SCOPING OPINION:

Proposed A47 Wansford to Sutton

Case Reference: TR010039

March 2018

Figure 1 – HE Environmental Constraints Plan

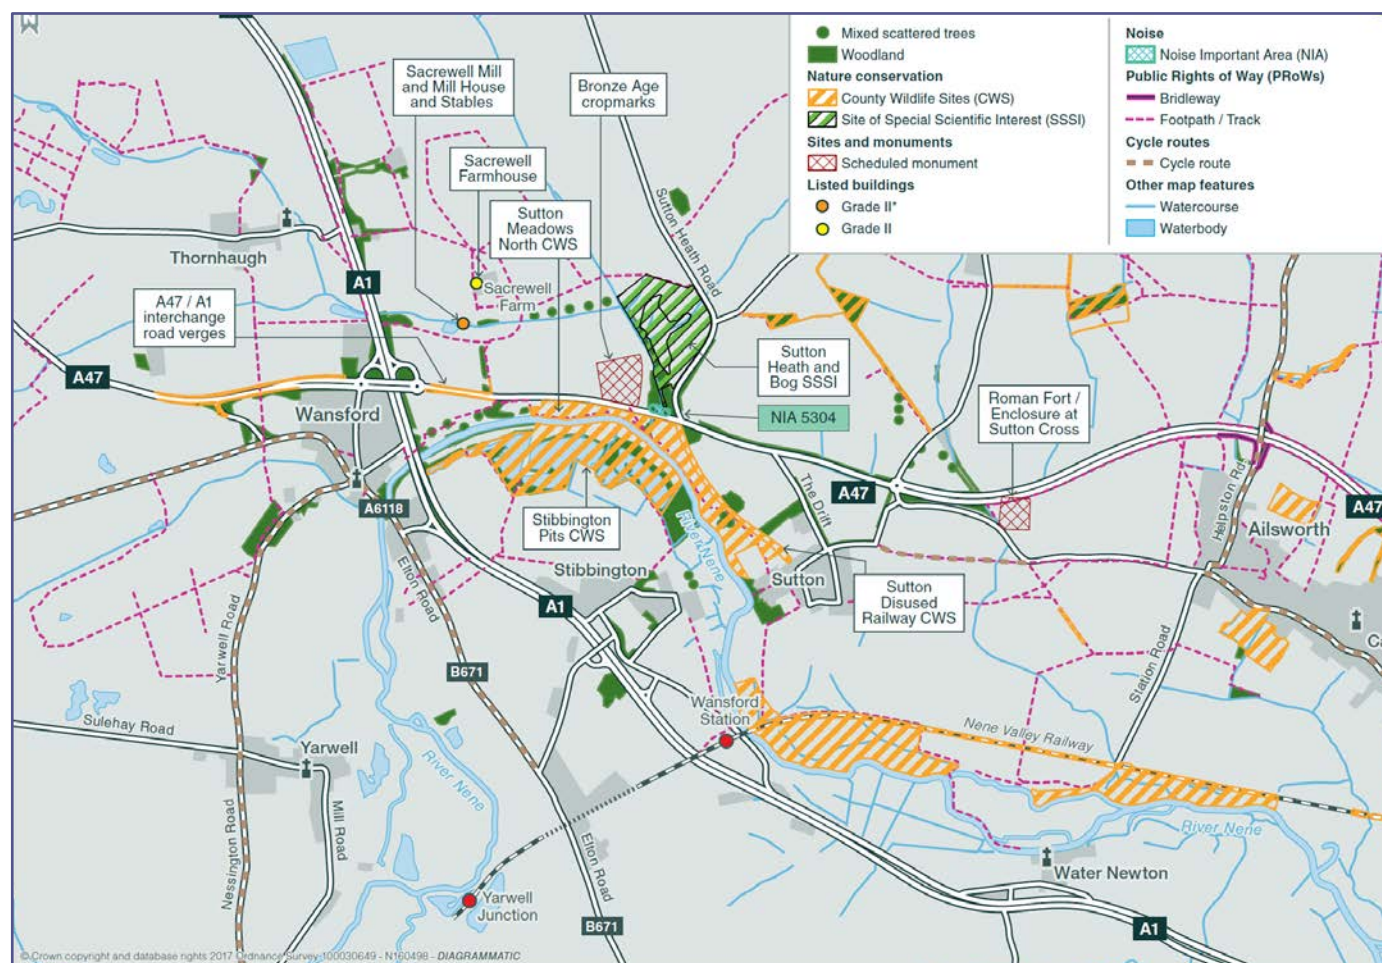
Despite the assurance given in para 1.4.2, it is very clear that the maps shown in Appendix B of the Scoping Report does not show all the environmental constraints that apply to the Project. In particular it ignores the various designations that apply to the banks of the River Nene.

Figure 2 – HE Route Option 1

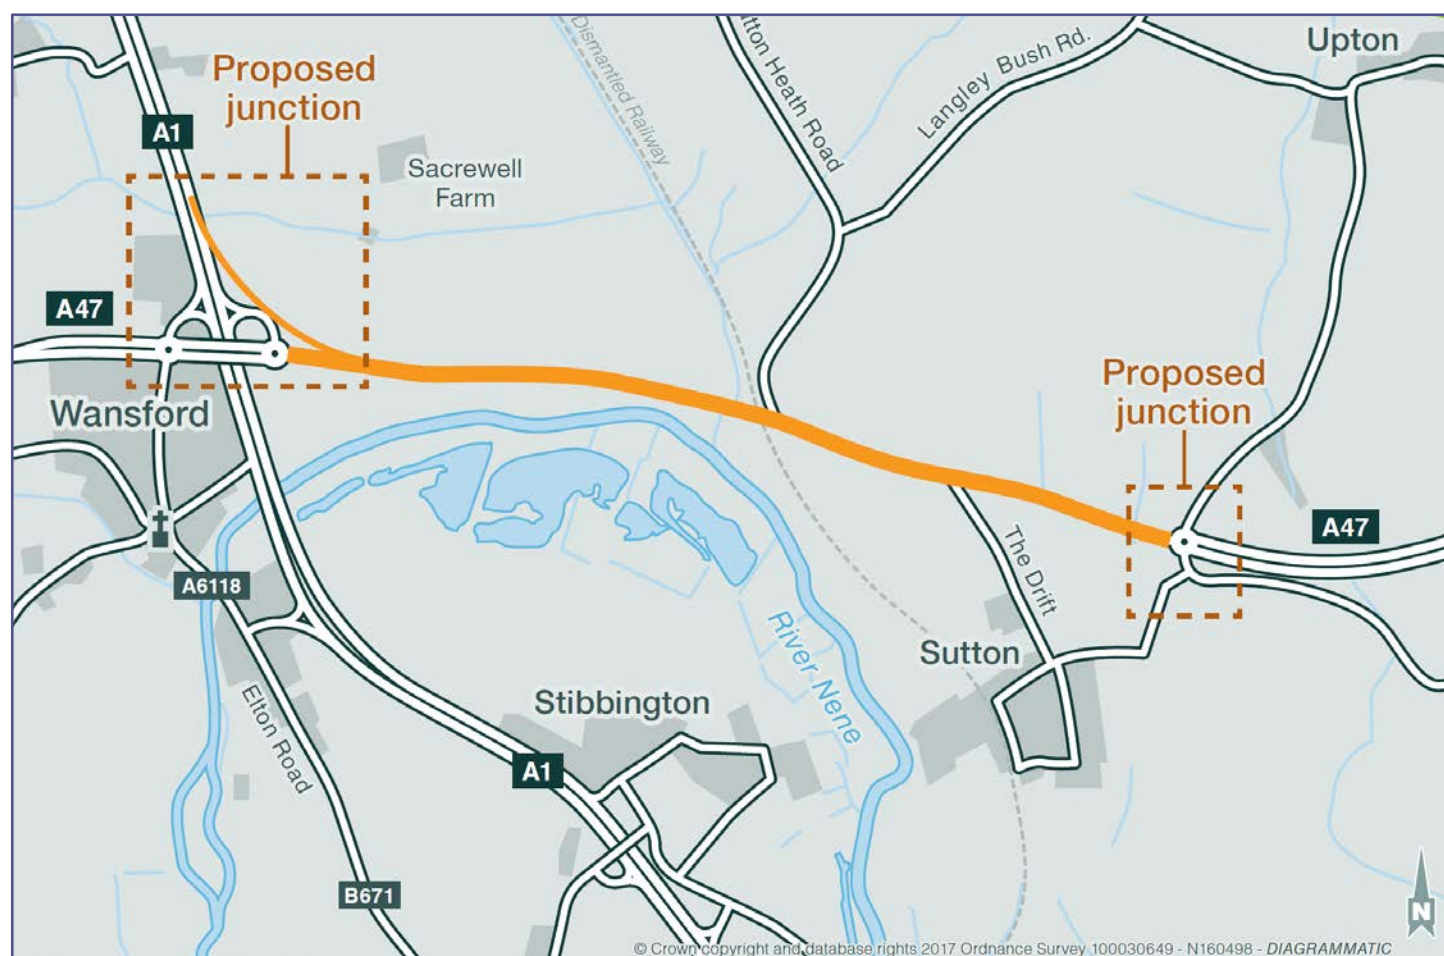
This route reused the existing road alignment and would have caused massive disruption during construction, and has made no provision for non-motorised traffic. The only merit of the scheme was to minimise land take. There was no indication how the junctions would be configured.

Figure 3 – HE Route Option 2

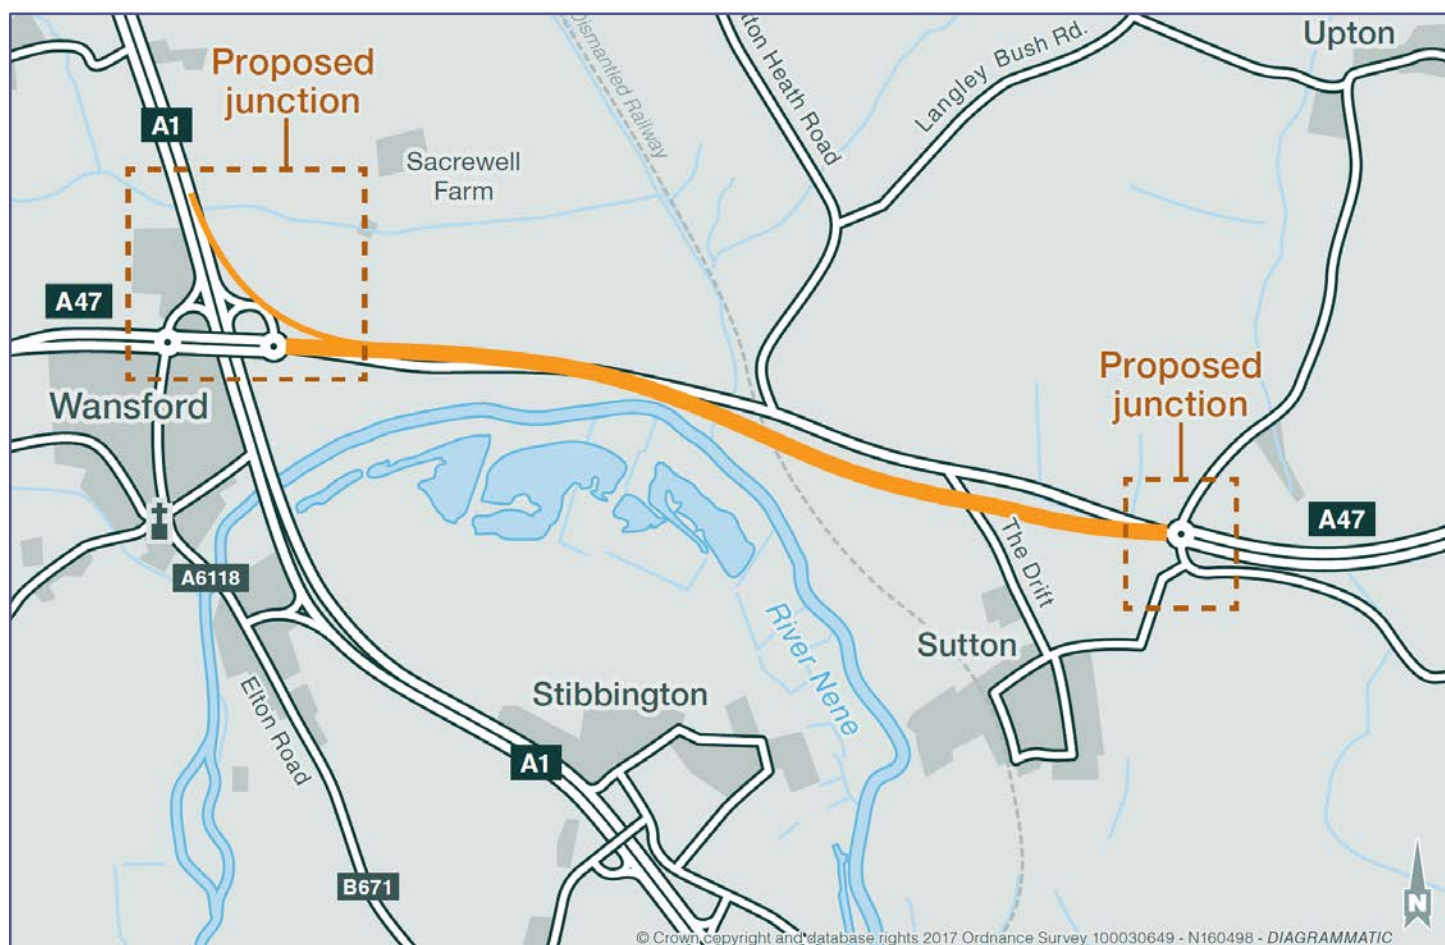
This route started off north of the existing road and then crosses to the south immediately to the west of the Scheduled Monument. This route produces the following problems:-

- The route involves the purchase of private land along the whole of its route.
- The route requires the purchase of one residential property, Deep Springs.
- There is no practical continuous route for non-motorised traffic.
- The long established Nene Way footpath will be disrupted.

Figure 4 – HE Route Option 3

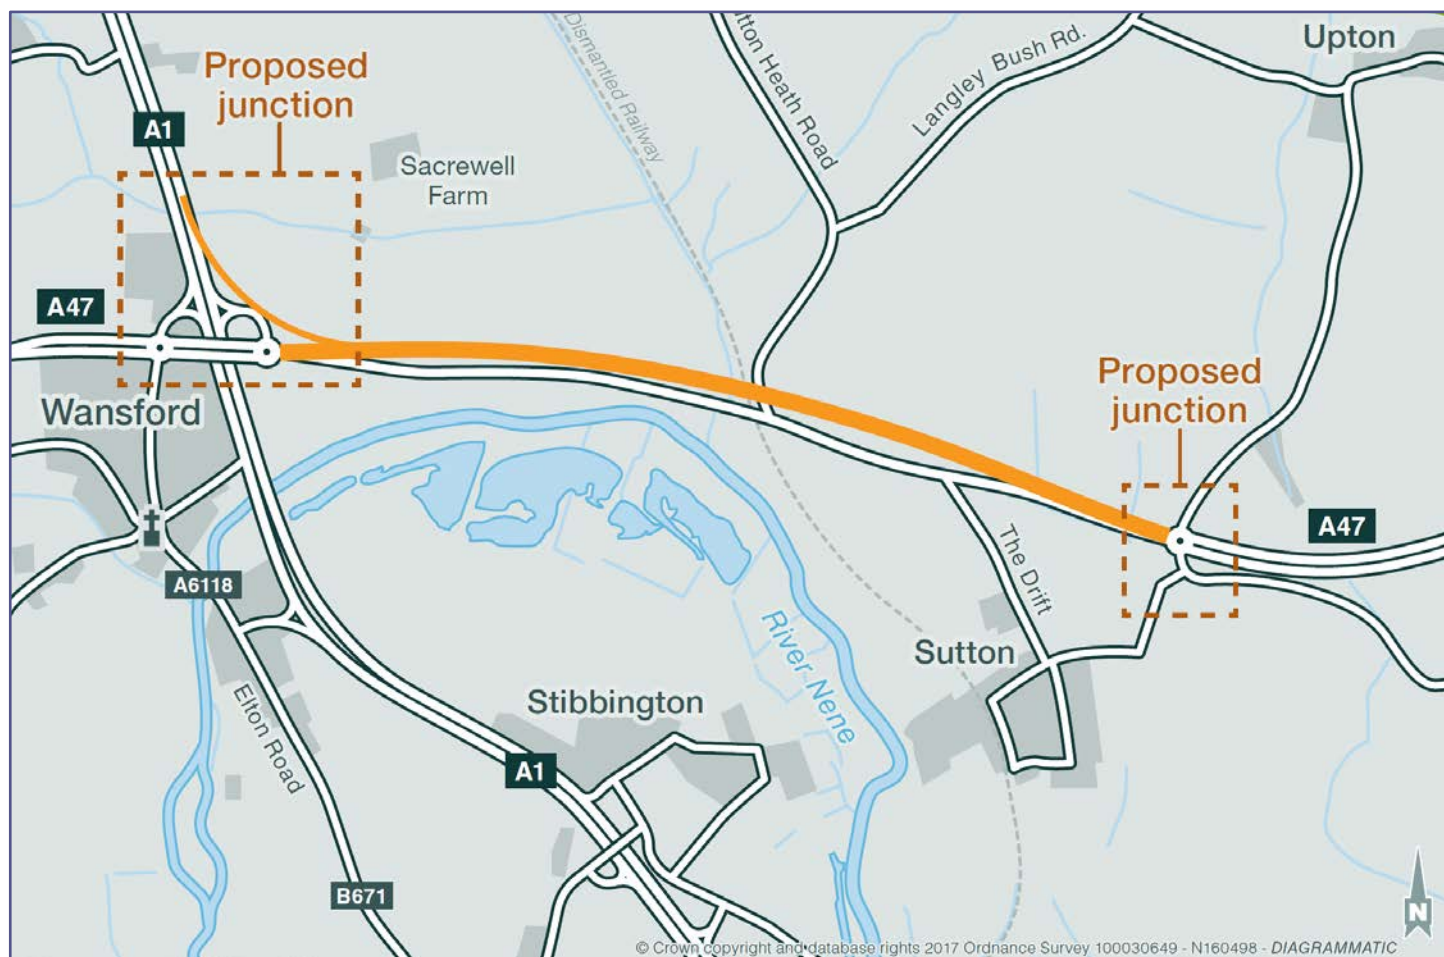
This route avoids all the environmental damage from going close to the river and, because it is completely off the existing roadline, there will be minimal disruption during construction.

The downside of this route is that it goes through the southern edge of the Scheduled Monument to the west of Sutton Heath Road. HE appears to have rejected this option purely because of this, a constraint that was already known when it offered the Option.

Figure 5 – Geophysical survey of the Scheduled Monument

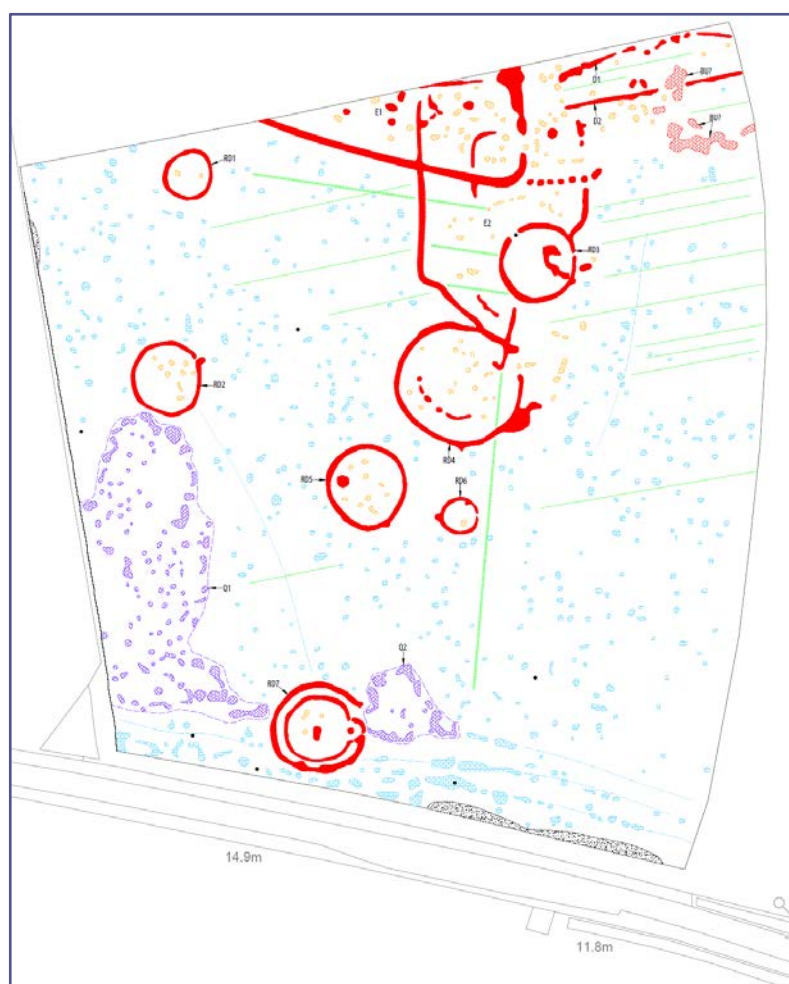
When the make up of the Scheduled Monument is examined, it is clear that the new road would only touch one feature of the many on the site. This feature is thought to be a ploughed out burial mound of a type that is quite common in the area. Professional advice is that fully excavating this feature would be of greater value than preserving it in its present state. Figure 5 shows a geophysical map of the Scheduled Monument clearly demonstrating the isolated feature at the southern edge.
